Access Compliance Report

Public Rights-of-Way

(Curb Ramps)

Intersection ID: 18920	Main Street: TYVOLA_RD	Cross Street: WESTPARK_DR	Location: NE
ADA ID: 8B9F2B156BF6	Ramp Type: Perp	Initial Pass/Fail: Fail	Overall Compliance: No
Severity Score: 12.5			
Codes/Mitigation Info/Possible Solution		Field Measurements/Component Compliance

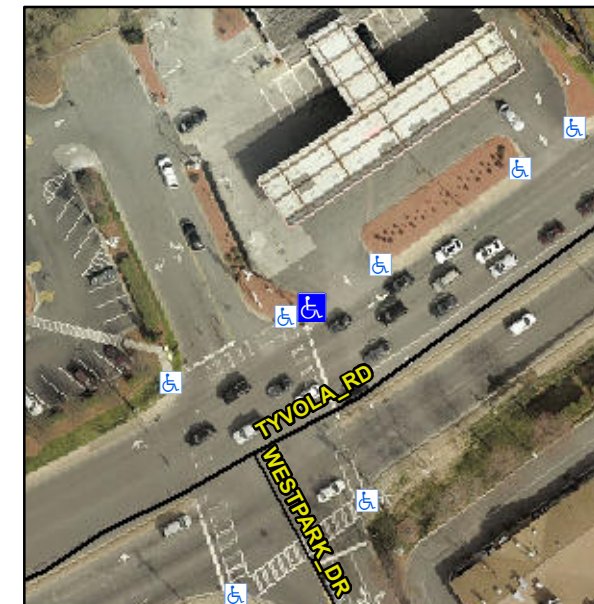
Not Found, R304.2.2

Compliance	Description	Data	Compliance	Description	Data
N/A	Ramp Length (in)	48.0	No	Ramp Slope (%)	8.8
Yes	Ramp Width (in)	48.0	Yes	Ramp XSlope (%)	1.2
N/A	Flare Type LT	N/A	N/A	Flare Type RT	N/A
N/A	Flare Slope LT (%)	N/A	N/A	Flare Slope RT (%)	N/A
N/A	Flare Traversable LT?	N/A	N/A	Flare Traversable RT?	N/A
N/A	Landing Length (in)	N/A	N/A	DWS Provided?	N/A
N/A	Landing Width (in)	N/A	N/A	DWS Contrast?	N/A
N/A	Landing Slope (%)	N/A	N/A	DWS Length (in)	N/A
N/A	Landing X Slope (%)	N/A	N/A	DWS Full Width?	N/A
N/A	Landing Curb? (Y/N)	N/A	N/A	DWS Offset (in)	N/A
N/A	Shared Landing?	N/A			
N/A	Gutter Ponding?	N/A	N/A	Gutter Slope (%)	N/A
N/A	Gutter Lip Ht (in)	N/A	N/A	Gutter X Slope (%)	N/A
N/A	Painted X Walk1?	No	N/A	Painted X Walk2?	N/A
	X Walk 1 Direction	To NW		X Walk 2 Direction	N/A
N/A	X Walk 1 Width (in)	N/A	N/A	X Walk 2 Width (in)	N/A
	X Walk 1 Slope (%)	2.8		X Walk 2 Slope (%)	N/A
	X Walk 1 X Slope (%)	1.8		X Walk 2 X Slope (%)	N/A

Remove & Replace Entire Ramp.
